Carolina Power & Light Company
MAY 22 1985

SERIAL: NLS-85-106

BRUNSWICK STEAM ELECTRIC PLANT, UNIT NOS. 1 AND 2
DOCKET NOS. 50-325 & 50-324/LICENSE NOS. DPR-71 & DPR-62
PIPING STRESS ANALYSES DAMPING VALUES

Figure 3.7.1.5

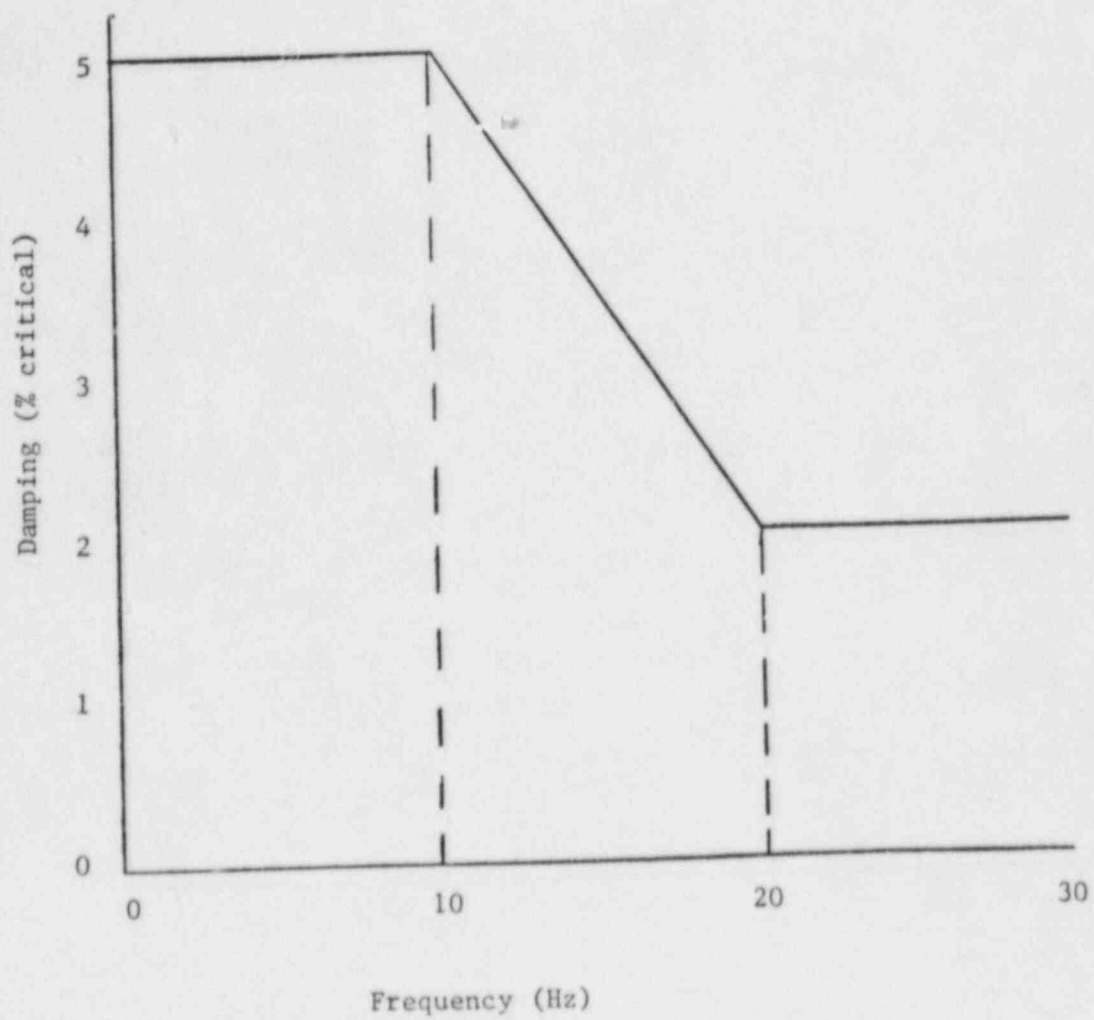
* For final reconciliation of pipe stress analysis or piping system backfits, damping values as defined in ASME Code Case N-411 (Figure 3.7.1.5) may be utilized for both OBE and DBE.

* For final reconciliation of pipe stress analysis or piping system backfits, damping values as defined in ASME Code Case N-411 (Figure 3.7.1.5) may be utilized for both OBE and DBE.

Increased damping values may have been applied for final stress reconciliation or piping system backfits in accordance with ASME Code Case N-411 (Figure 3.7.1.5). If so, the following criteria were also used:

- a) A three-dimensional square root of the sum of the squares (SRSS) earthquake combination in lieu of a two-dimensional SRSS combination.
- b) Regulatory Guide 1.92 modal combinations accounting for closely-spaced modes in lieu of a straight SRSS of all modes.
- c) A rigid cut off value of 33 Hz in lieu of 20 Hz.
- d) A pipe displacement check performed if existing pipe supports were moved, modified, or eliminated.
